# TECHNICAL BULLETIN

**DATE:** FEBRUARY 28, 1994  
**MODEL YEAR:** 1992 - 1994  
**CHASSIS MODEL:** UD1800 -  
UD3000SD  
**BULLETIN #:** EC - 04  
**FILE IN ENGINE SECTION**

## FE6TA ENGINE FAN SPACER/PILOT FOR RED DOT AIR CONDITIONER

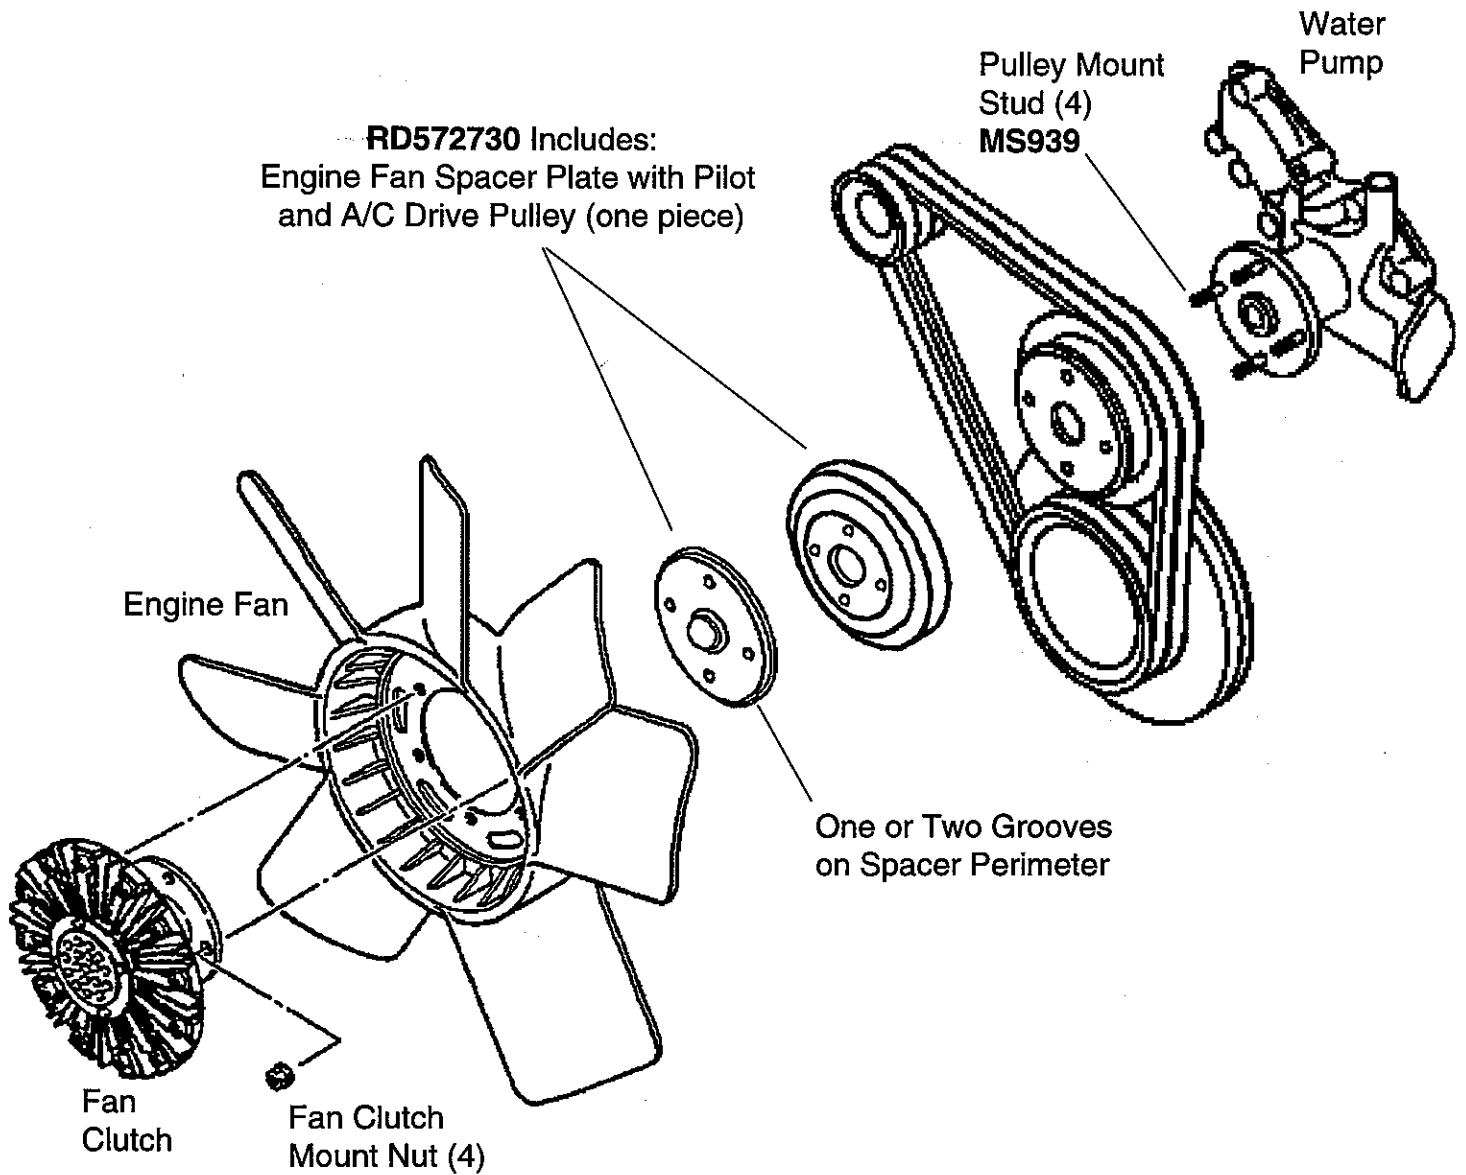
**CHANGE NOTICE:** With the introduction of Red Dot air conditioning in 1992, vehicles with the FE6TA engine (UD1800 - UD3000SD) required the addition of a spacer between the engine fan and the water pump/air conditioning pulley arrangement to provide the engine fan clearance with the freon compressor, and a pilot in the spacer to align the fan clutch with the water pump shaft. The two-piece spacer/pilot, part number UP - 101, was included in all Red Dot installation kits for FE6TA-equipped vehicle models after November 1992. For vehicles which received Red Dot installations prior to November 1992, Product Improvement # 020 was released to address these vehicles.

A new design one-piece spacer/pilot was introduced in April 1993 to replace the former two-piece spacer. The new one-piece spacer/pilot, part number RD572730, also includes a new air conditioner drive pulley. The new spacer is identified by either one or two grooves cut into the outer perimeter of the spacer.

**SERVICE NOTICE:** When servicing the engine fan, fan clutch, water pump pulleys, or the water pump, the new version spacer/pilot/pulley part number RD527370 should be installed in the customer's vehicle to replace the former version two-piece spacer/pilot and the air conditioning pulley. Refer to PI - 020 (REV. 2/94) for installation instructions.
